REMARKS

Drawings

Fig. 6

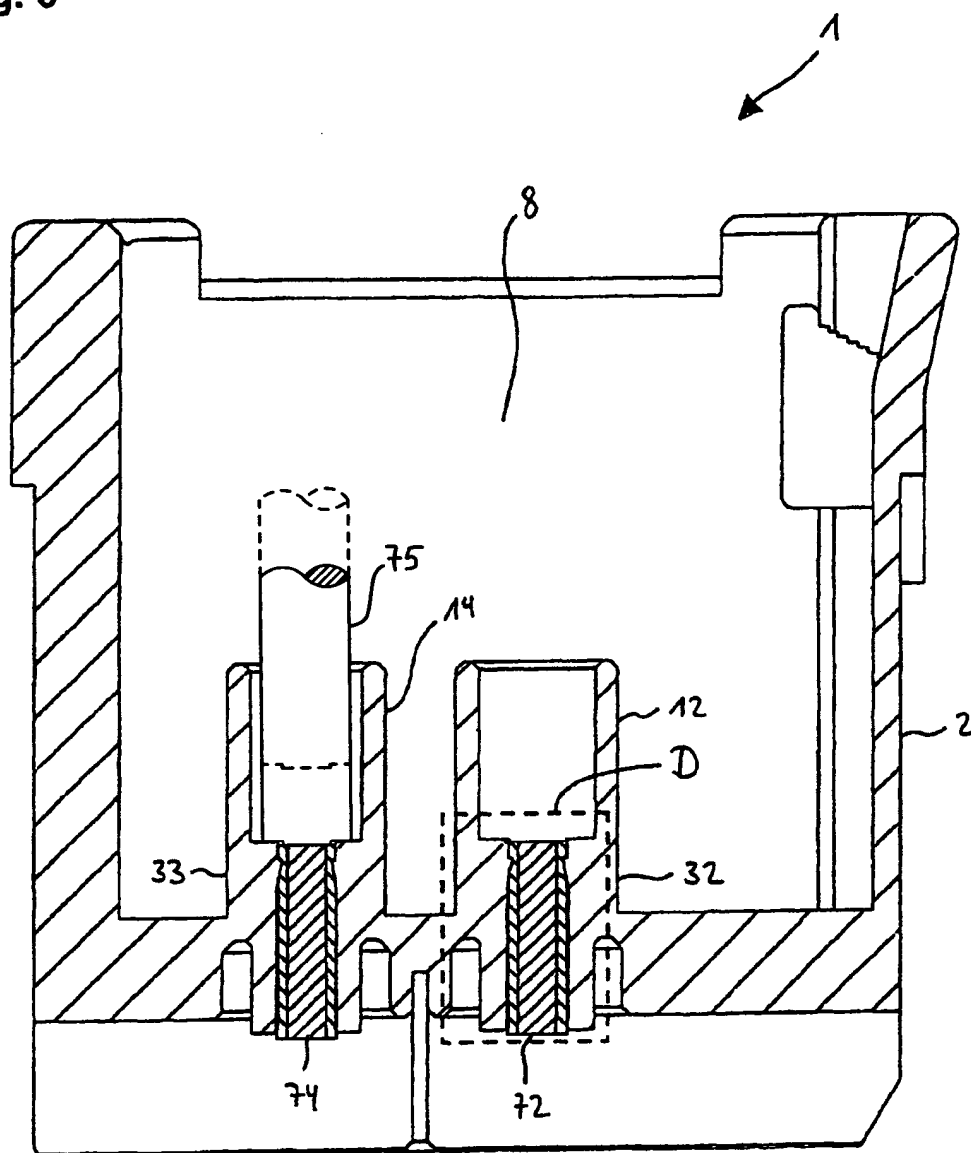
FIG. 6: Please cancel sheet no. 6 and substitute amended replacement sheet no. 6. The foregoing amendment adds a showing of mounting die 75 fully inserted to working position (solid lines) and as partially retracted (phantom line). These corrections are shown in red ink in the accompanying copy of FIG. 6 on sheet 6 of the drawings as filed.

Amended FIG. 6 shows the mounting die (now numbered "75") described in the specification at Page 5, Lines 30-33 and Page 6, lines 1-30 as filed, and also referenced in claim 25 as filed. This therefore overcomes the Examiner's objections to the Drawings, i.e., that the mounting die feature be shown as referenced in claim 25, without adding new matter. The description of FIG. 6 has also been amended to conform to this drawing amendment.
